North Little Rock Planning Commission
January 10, 2023 - Agenda / Public Hearing 4:00 PM
City Council Chambers – 300 Main Street, NLR, AR 72114

**North Little Rock Planning Commission
Minute Summary
December 13, 2022**

**SITE PLAN REQUEST TO AUTHORIZE A
 SECURITY SYSTEM FOR:
 DOGGETT FREIGHTLINER
 11700 VALENTINE RD
 NORTH LITTLE ROCK, AR 72117**

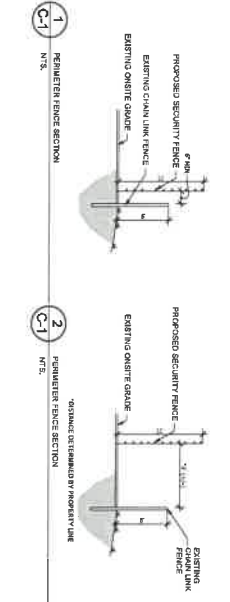
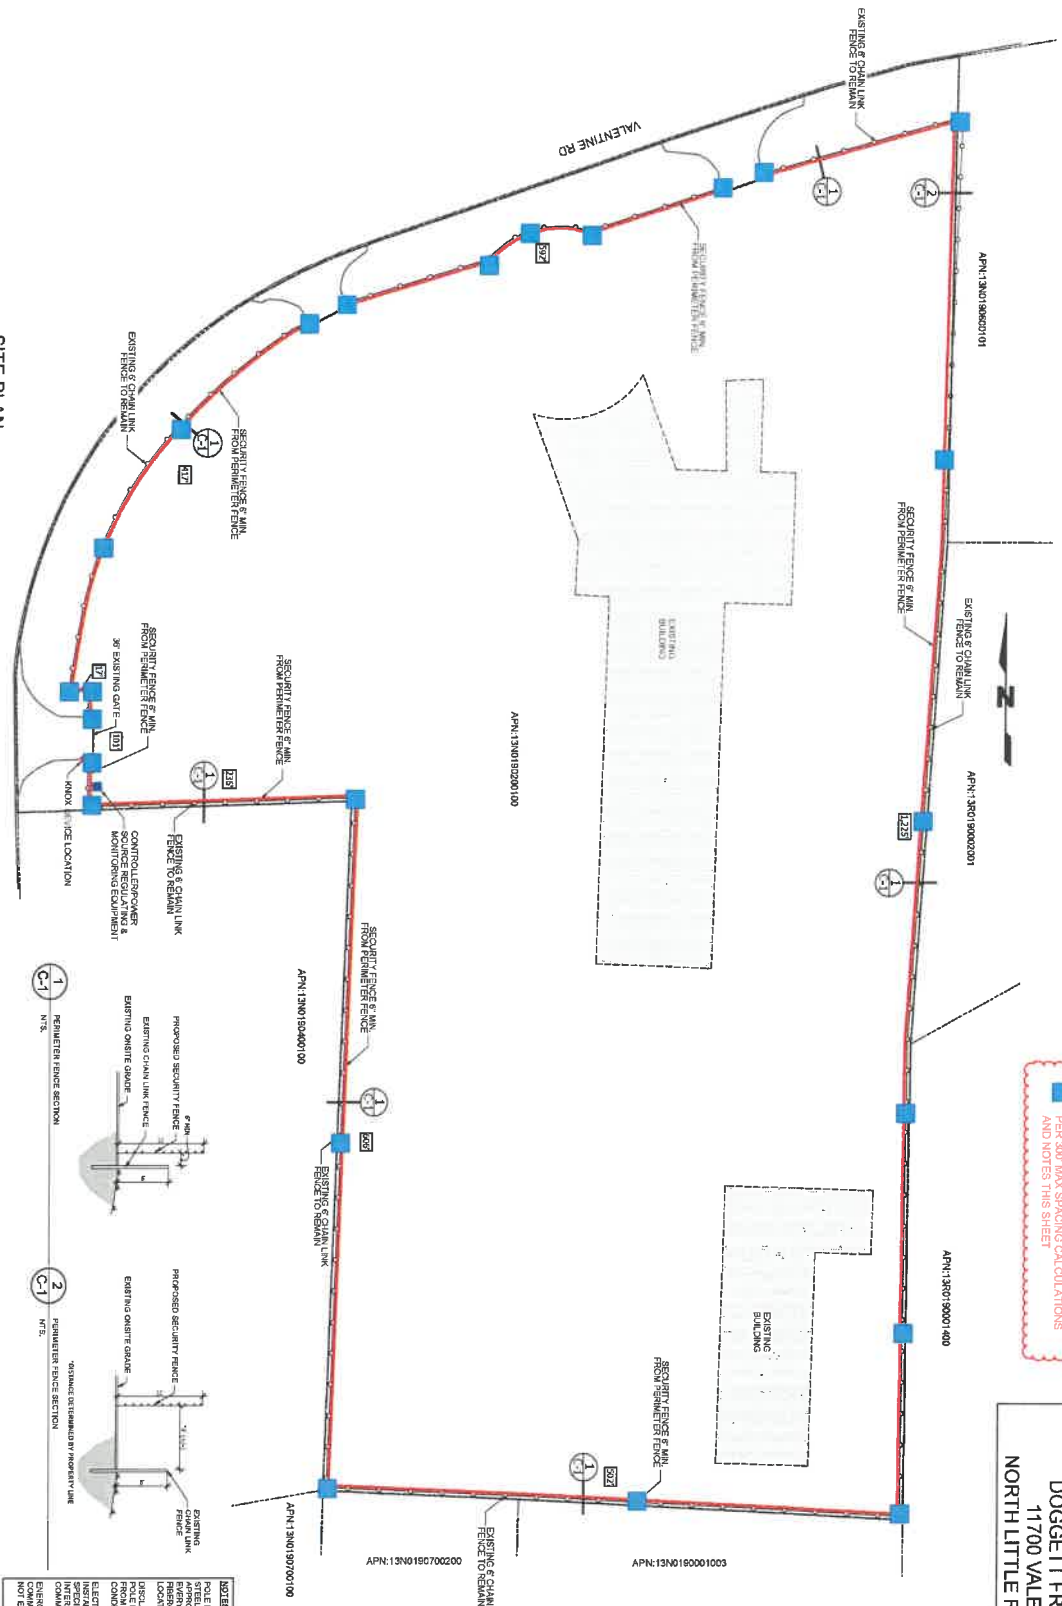
Conditions to Consider:

1. Unless otherwise specified herein, electric fences shall be constructed or installed in conformance with the specifications set forth in International Electrotechnical Commission (IEC) Standard No. 60335-2-76.

3. The electric charge produced by the fence upon contact shall not exceed energizer characteristics set forth in Paragraph 22.108 and depicted in Figure 102 of IEC Standard No. 60335-2-76.

13. No electric fence shall be installed until after commercial plans review by the City and confirmation the plans for the fence meet the requirements of the Zoning Ordinance and an

Special Use #2023-01

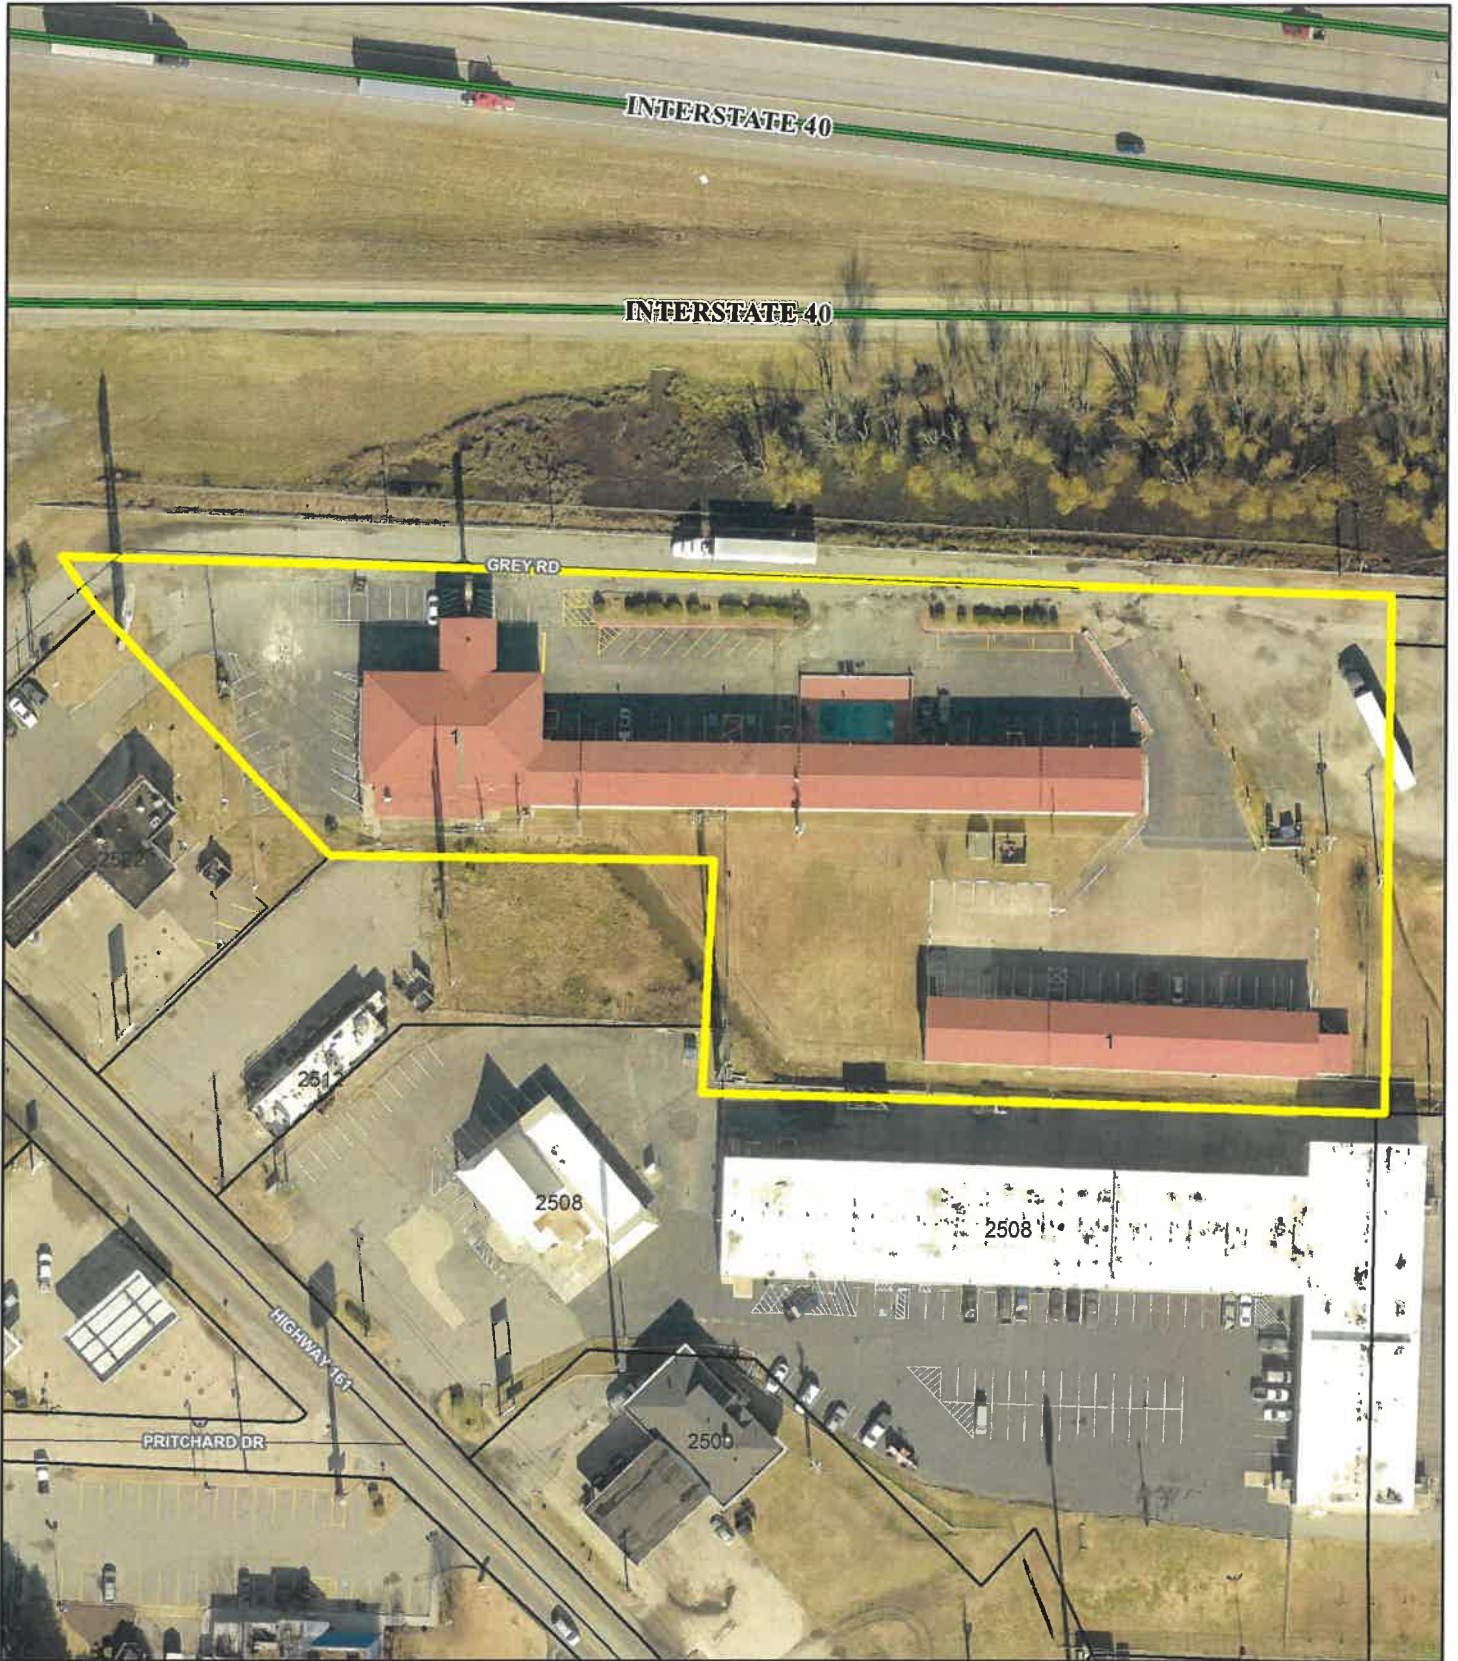
1. Applicant must meet all applicable Federal, State, County and City requirements.
2. Business license to be issued after Planning Staff confirmation of requirements.
3. Applicant/owner understands that failure to comply with these conditions may result in loss of the Special Use and/or loss of Business License.
